**KINGSTON PLANNING APPLICATION 25/02749/OUT  
(= ELMBRIDGE APPLICATION 2025/2765)  
*Hook Park***

Claygate Parish Council **objects** to the above application on the following grounds:-

## **Annex A Highway Considerations**

Hook Park Development proposal

Figure XX Dropped pin marks high point of clash between traffic flows, those decelerating to exit A309 and those accelerating to merge onto A309 from on slip.

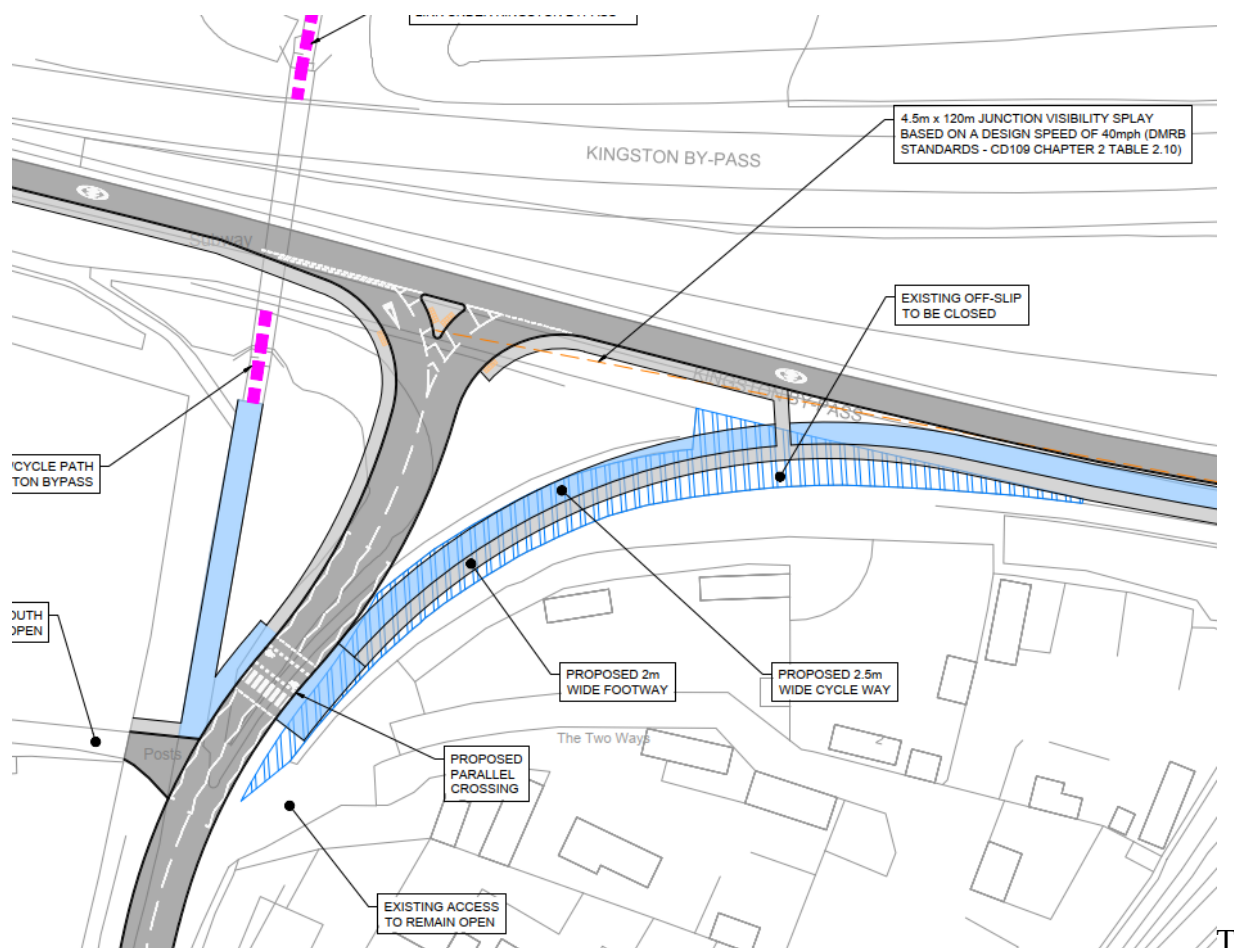
24. SSD and visibility splays: General arrangement of north access, drawing 25038-MA-XX-XX-DR-C-0100, notes a SSD of 160m to give way of roundabout, based on 50mph design speed and CD 116 Chapter 3, figure 3.43. However, in this measurement no account has been taken of Note 2 of clause 3.42, visibility requirements include no obstructions to signs, street furniture or planting. With note 2 observed, then SSD drops to less than 85m, bearing in mind the deflecting bend of the approach to the roundabout. This is well below the standard, more than one step of relaxation.

In 2014 Surrey CC was asked to allow a small operation accessing this site in the same location as the proposed roundabout. This was refused and clearly highlighted that an access onto the A309 would be a significant risk to highway safety. This was because of high vehicle speeds, the slow acceleration of HGV's leaving the site, the lack of achievable sightlines and achievable taper lanes. The current proposal shows a 90m merge taper to the western arm of the roundabout. This is acceptably above the minimum of 70m if the minor road is not a through road. However, the same cannot be said of the next proposed junction at Woodstock Lane South.

**Figure 5.4 Characteristics of Collisions Along ATZ**

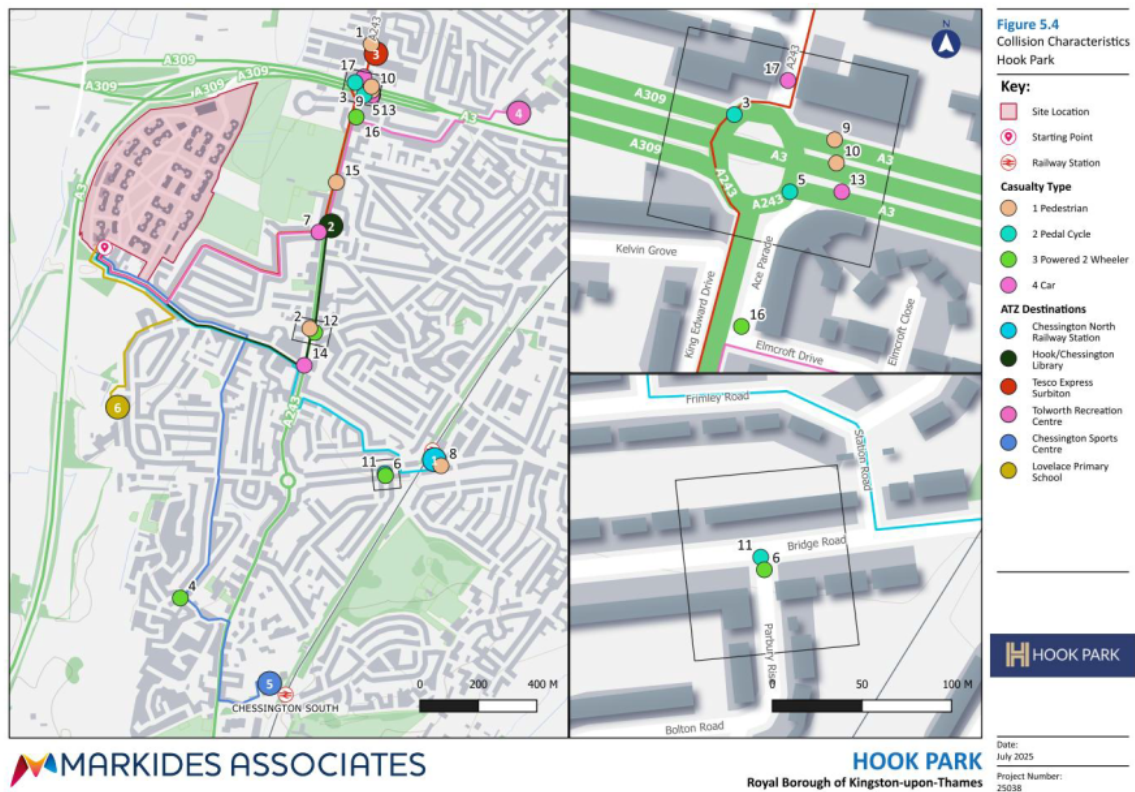
Despite assurances that increased traffic flows will be low, the evidence is absolutely the opposite. The main junctions that are expected to be used are already at peak capacity during peak periods, causing queuing and increasing clash between pedestrians and motorised vehicles. In particular, we note in the Environmental Statement Appendix 15.4

Showing the locations of KSIs fatal and serious accidents on the Hook roundabout. The whole access to the new development would be to and from London via this route as well as to and from M25. This will increase substantially the risk of collision and injury, as well as congestion increase in an area already highly congested throughout the working day. This is acknowledged by para 5.3.7 cited above.
